TO: DCHC MPO TC
 FROM : Filmon Fishastion, MPO Staff
 SUBJECT: FY2024-2033 TIP Amendment #4 Public Comments

RE: Comments on Amendment #4 to the FY2024-2033
Transportation Improvement Program (TIP)

Thank you for the opportunity to offer the attached comments on DCHC MPO's Amendment #4 to the FY2024-2033 Transportation Improvement Program (TIP). These comments are for project HE-0007D to add turn lanes and a traffic signal at the intersection of Old Oxford Road and Snow Hill Road in Durham County.

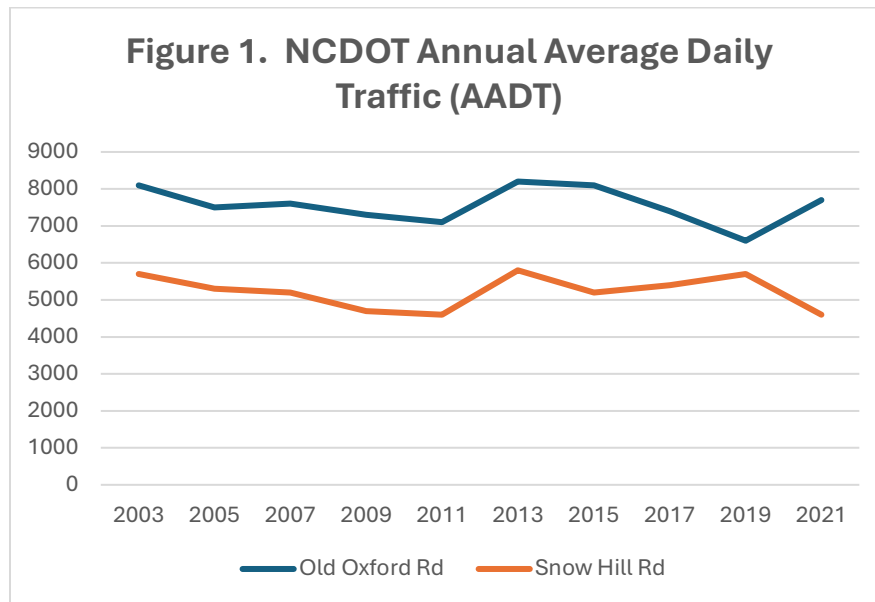
Current traffic volumes at the intersection are about 8000 AADT on Old Oxford and 6000 AADT on Snow Hill Rd (see figure 1). Based on NCDOT SaFID charts, the safest feasible intersection at current traffic volumes is an all-way stop. If traffic volumes increase a bit, the safest feasible intersection is a single lane roundabout.

Figure A-1. Cost Reduction Opportunities

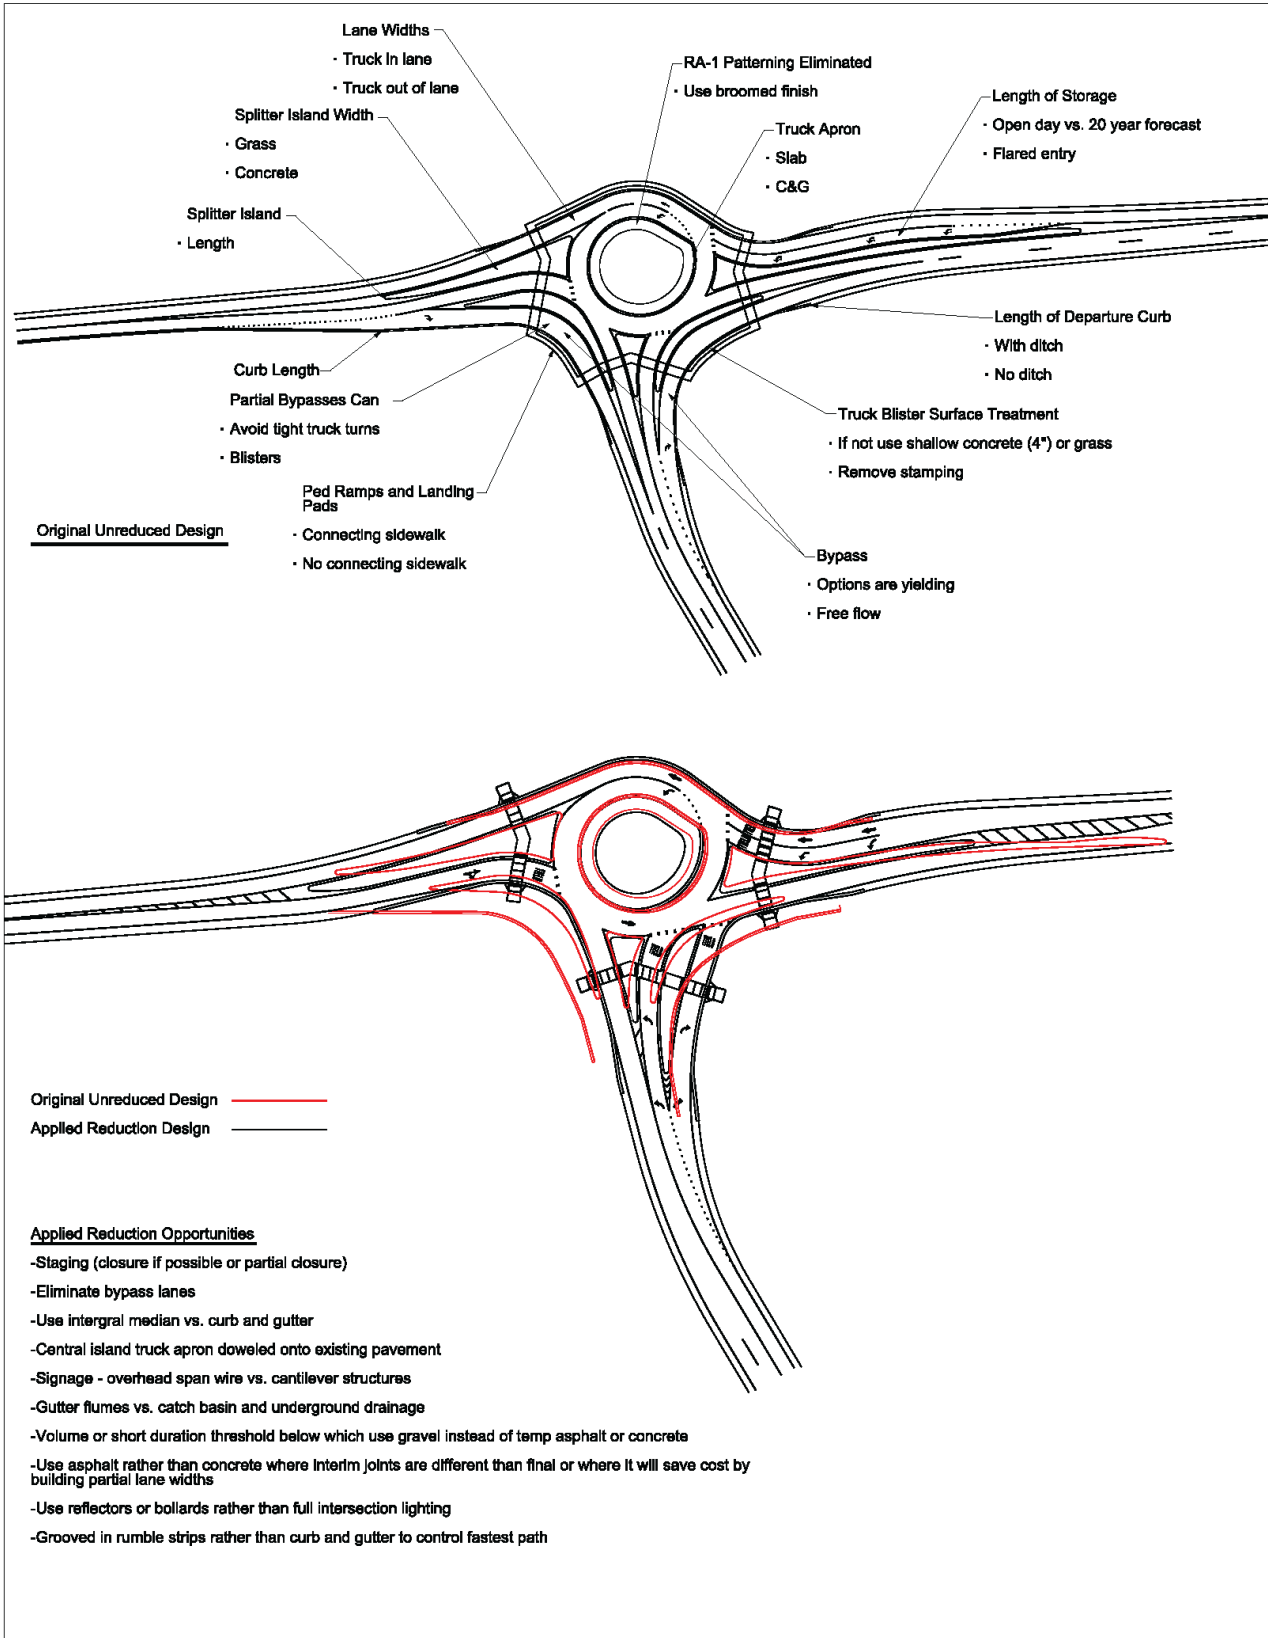
Figure A-1 shows an example of a real project, through the course of practical design considerations, the red-line layout was reduced to the black-line layout. Cost savings on this roundabout are in the range of about 20%.
